**ATTACHMENT G**  
**CLOSURE PLAN**

### CLOSURE PLAN

This Permit Attachment contains the Closure Plan that describes the activities necessary to close the Waste Isolation Pilot Plant (**WIPP**) individual units and facility. Since the current plans for operations extend over several decades, the Permittees will periodically reapply for an operating permit in accordance with 20.4.1.900 NMAC (incorporating 40 CFR §270.10(h)). Consequently, this Closure Plan describes several types of closures. The first type is panel closure, which involves constructing closures in each of the underground hazardous waste disposal units (**HWDUs**) after they are filled. The second type is partial closure, which can be less than the entire facility and therefore less than an entire unit as described herein for the Waste Handling Building (**WHB**) Unit and the Parking Area Unit (**PAU**). The third type of closure is final facility closure at the end of the Disposal Phase, which will entail “clean” closure of all remaining surface storage units and construction of the four shaft seal systems. Finally, in the event a new permit is not issued prior to expiration of an existing permit, a modification t

**Figure G-2  
WIPP Panel Closure Schedule**

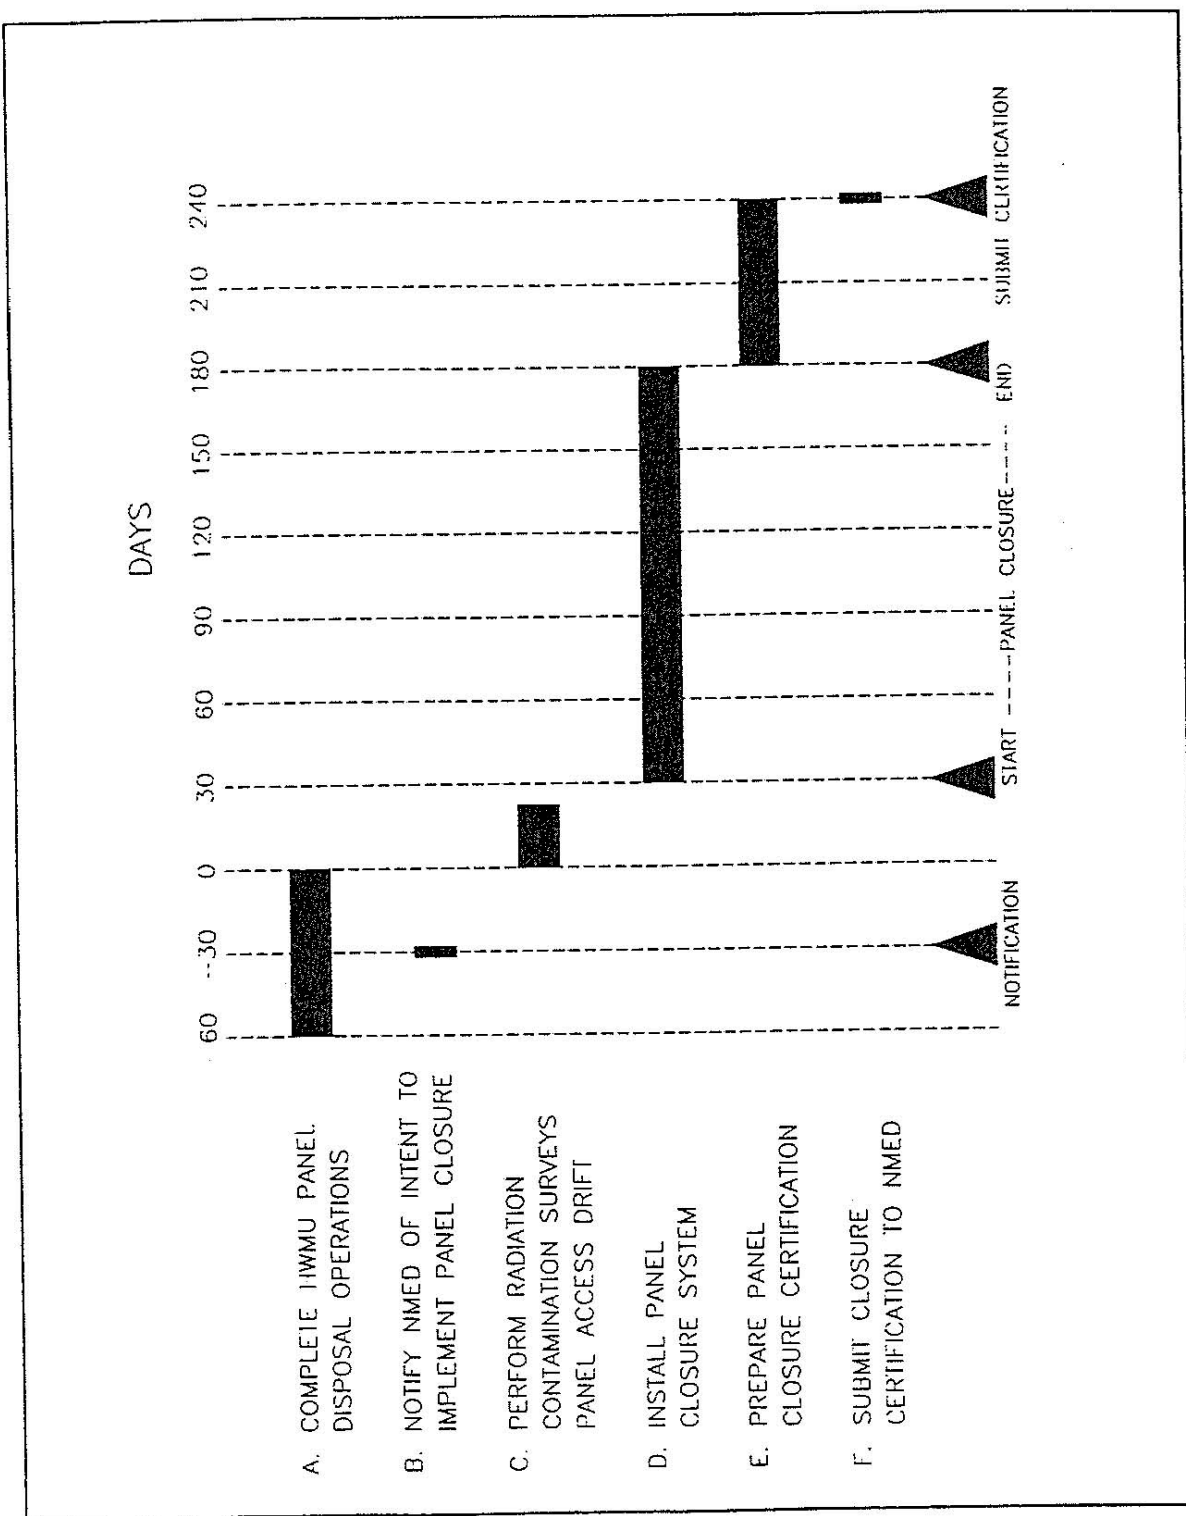
The anticipated schedule for the closure of the underground HWDUs ~~known as Panels 3 through 8~~ is shown in Figure G-2. This schedule assumes there will be little contamination within the exhaust drift of the panel. Underground HWDUs should be ready for closure according to the schedule in Table G-1. These dates are estimates for planning and permitting purposes. Actual dates may vary depending on the availability of waste from the generator sites.

In the schedule in Figure G-2, notification of intent to close occurs 30 days before placing the final waste in a panel. Once a panel is full, the Permittees ~~shall~~ will initially block ventilation through the panel as described in Permit Attachment A2, Section A2-2a(3) "Subsurface Structures." and then ~~shall~~ will assess the closure area for ground conditions and contamination so that a definitive schedule and closure design can be determined. If as the result of this assessment the Permittees determine that a panel closure cannot be emplaced in accordance with the schedule in this Closure Plan, a modification ~~shall~~ will be submitted requesting an extension to the time for closure.

**Figure G-4**  
**Design of a Panel Closure System**

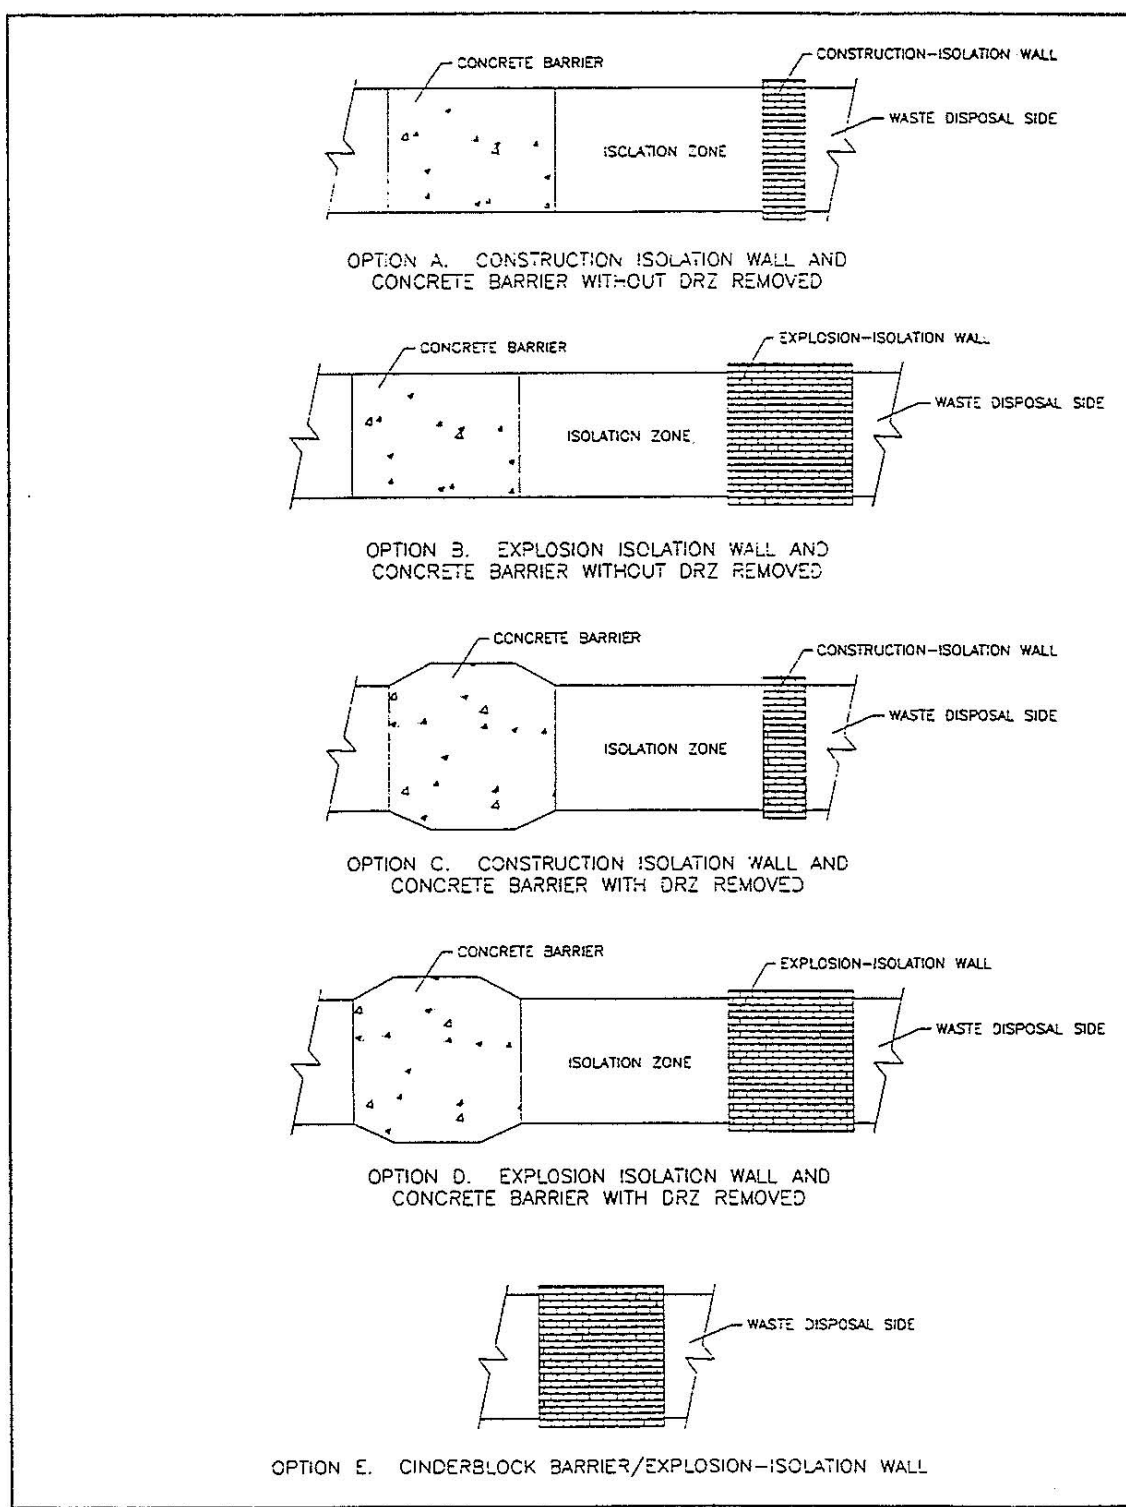
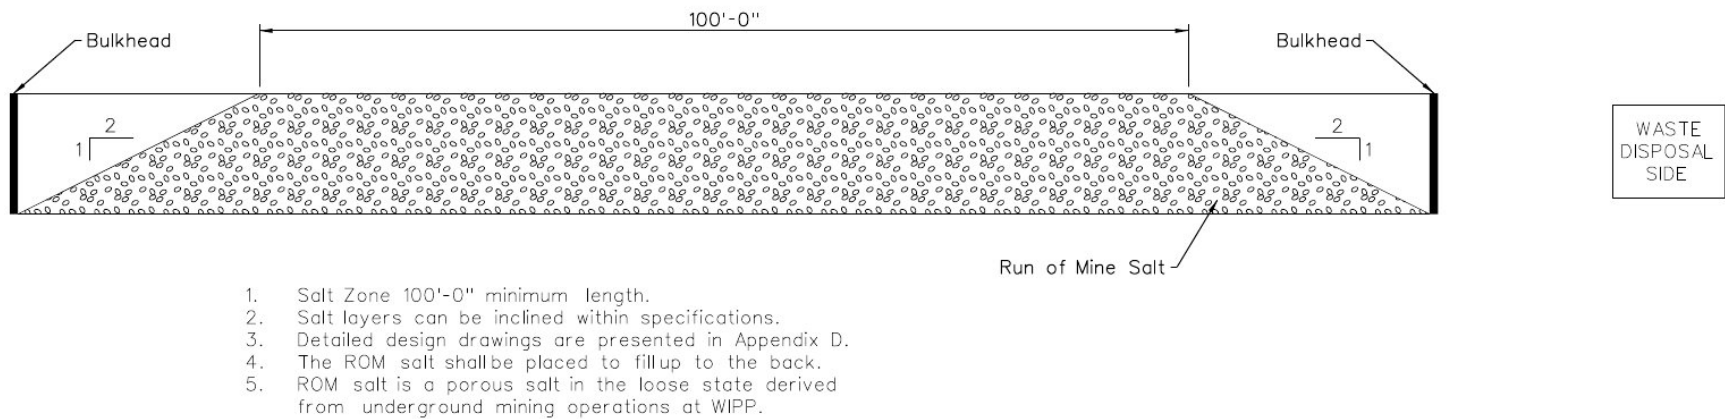
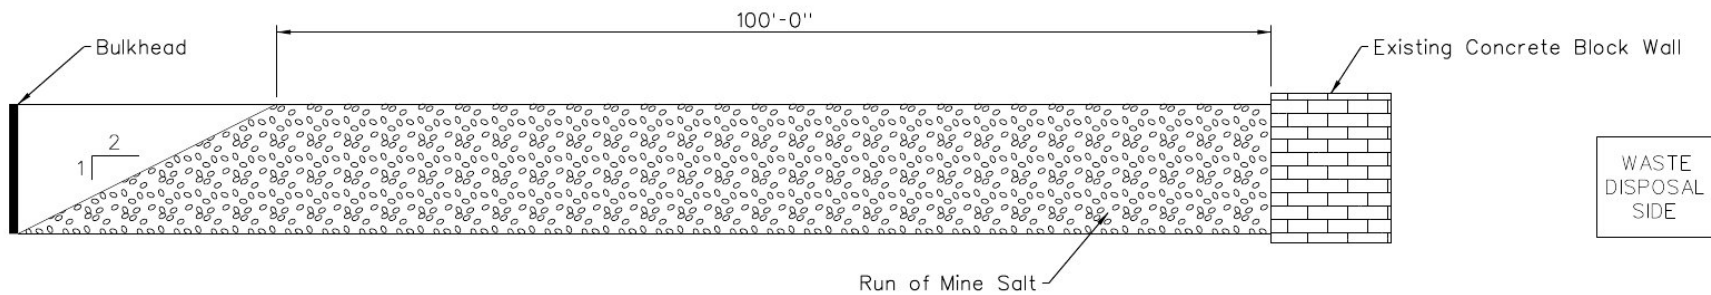
24 ~~The approved design for the panel closure system calls for a composite panel barrier system~~  
25 ~~consisting of a rigid concrete plug with removal of the DRZ, and an explosion isolation wall. The~~  
26 ~~design basis for this closure is such that the migration of hazardous waste constituents from~~  
27 ~~closed panels during the operational and closure period would result in concentrations well~~  
28 ~~below health-based standards. The source term used as the design basis included the average~~  
29 ~~concentrations of VOCs from CH waste containers as measured in headspace gases through~~  
30 ~~November 2010 January 1995. The VOCs are assumed to have been released by diffusion~~  
31 ~~through the container vents and are assumed to be in equilibrium with the air in the panel.~~  
32 Emissions from the closed panel occur at a rate determined by gas generation within the waste  
33 and creep closure of the panel.

34 Figures G-4 and G-5 show a diagram of the panel closure design and installation envelopes.  
35 Permit Attachment G1 provides the detailed design description and associated specification and  
36 drawings ~~the design analysis for the panel closure system. Although the permit application~~  
37 ~~proposed several panel closure design options, depending on the gas generated by wastes and~~

the age of the mined openings, the NMED and EPA determined that only the most robust design option (D) would be approved. This decision does not prevent the Permittees from continuing to collect data on the behavior of the wastes and mined openings, or proposing a modification to the Closure Plan in the future, using the available data to support a request for reconsideration of one or more of the original design options. If a design different from Option D as defined in Permit Attachment G1 is proposed, the appropriate permit modification will be sought.
